Planning Commission Staff Report

April 13, 2016
Item No. 5.a.

- SUBJECT:** PUD-112
- APPLICANT:** Amanda Gagliardi
- PROPERTY OWNERS:** Beatrice L. Nolan & John C. Dwyer
- PURPOSE:** Application for Planned Unit Development (PUD) Development Plan for a four-lot single-family residential development and related improvements at 1027 Rose Avenue which include the retention of the existing single-family residence, the construction of an approximately 3,443-square-foot, one-story, single-family residence, and two future custom homes.
- LOCATION:** 1027 Rose Avenue
- GENERAL PLAN:** Medium Density Residential
- ZONING:** PUD-MDR (Planned Unit Development – Medium Density Residential) District
- EXHIBITS:**
- A. [Draft Conditions of Approval](#)
 - B. [Project Plans](#), [Green Building Checklist](#), [Arborist Report by HortScience](#), and [Design Guidelines](#)
 - C. [Ordinance No. 1874 Approving PUD-19](#)
 - D. [Location Map and Noticing Map](#)

Figure 3: Front Elevation

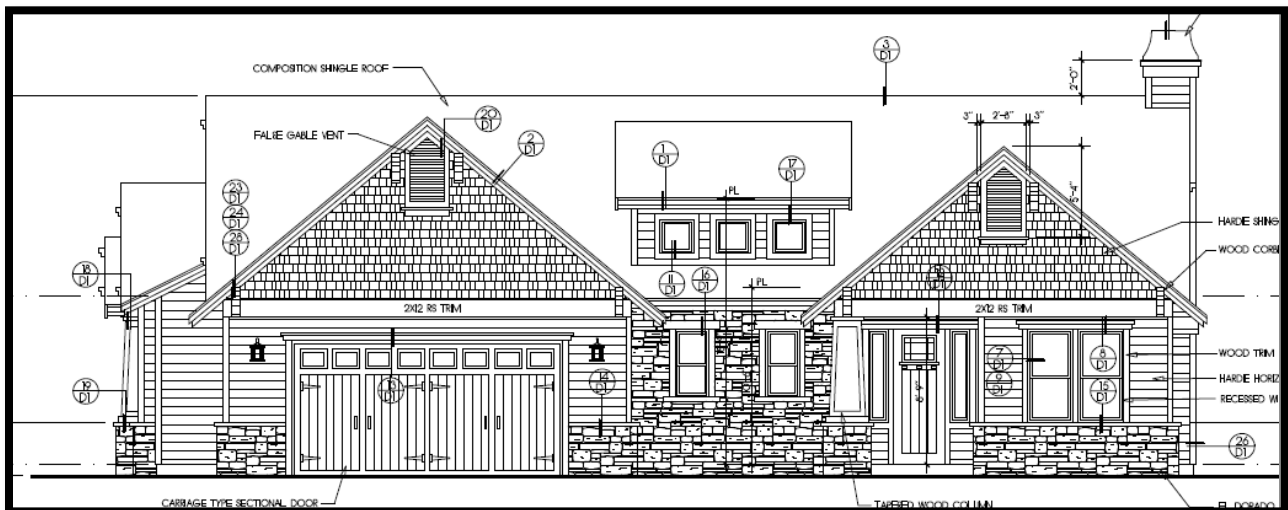
Given that it is a Craftsman style home, the proposed house should incorporate a front porch. As such, staff has included a condition of approval requiring a porch be incorporated.

Figure 4: Floor Plan

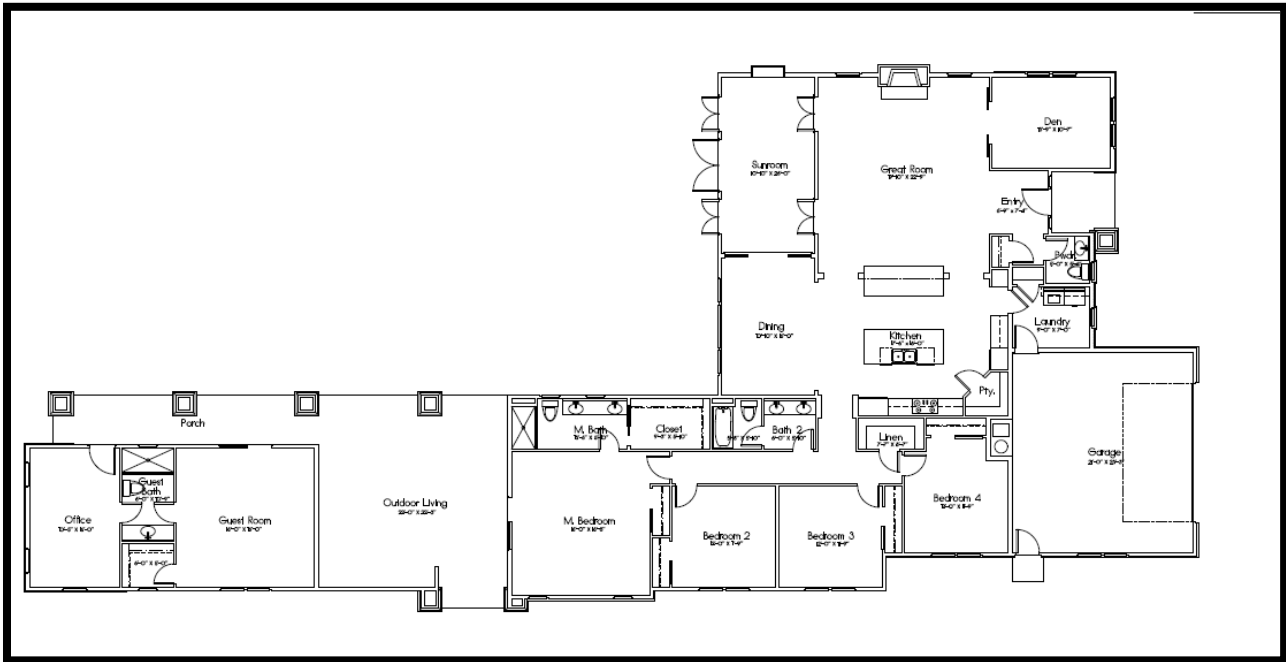
The floor plan in Figure 4 indicates that a guest room and adjoining bathroom and office would be located to the north of the main residence, on the other side of a roofed outdoor space. No kitchen is proposed within the guest room unit. Staff has included a condition requiring that a restrictive covenant be recorded with the land stating that the guest room unit is not to be used as a second unit, and that prior City approval is required to convert the space to a second unit.
